**Addendum Number Two**

To the Drawings and Specifications for  
The North Re-Roofing Project  
For Oxford Jr/Sr High School  
Oxford, Kansas

Issued: August 5, 2019

DETAIL - N.T.S.

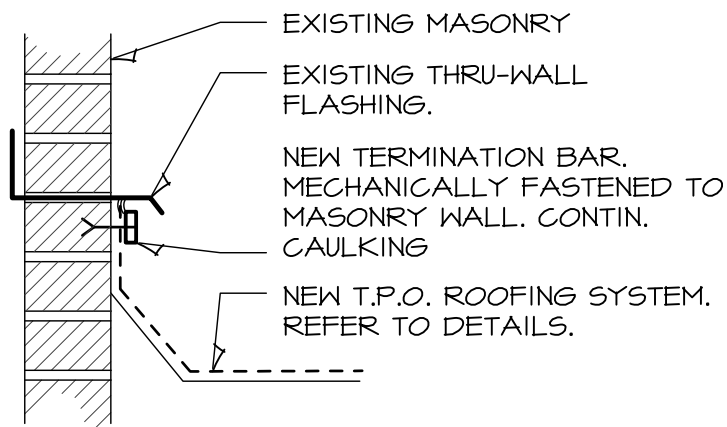
- 1.1 *The bid date shall remain Monday, August 12<sup>th</sup>, 2019 at 319 E. College, Oxford, Kansas 67219, up to and until 2 p.m.*
- 1.2 Carlisie Syntec, Sure-weld, TPO, roof system is an approved equal.
- 1.3 See attached detail:

EXISTING THRU-WALL FLASHING IS TO REMAIN. CONTIN. RE-CAULK SEAM. TYP.

EXISTING REGLET IS TO BE REMOVED.

TURN NEW T.P.O. ROOFING UP PARAPET WALL AND TERMINATE UNDERNEATH EXISTING THRU-WALL FLASHING. USE TERMINATION BAR W/ CONTIN CAULKING SEAM AT TERMINATION POINT.

**A ROOF PLAN**  
SCALE: 1" = 40'-0" NORTH

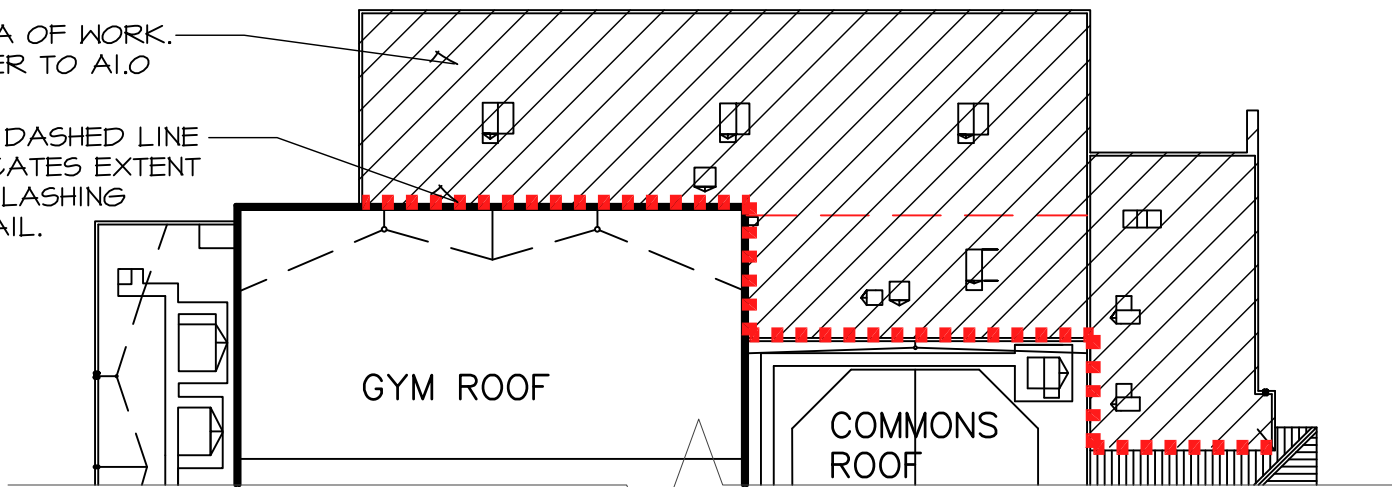
EXISTING ROOF SYSTEM TO BE REMOVED. REFER TO DRAWINGS & SPECIFICATIONS.

AREA OF WORK. REFER TO A1.0

RED DASHED LINE INDICATES EXTENT OF FLASHING DETAIL.
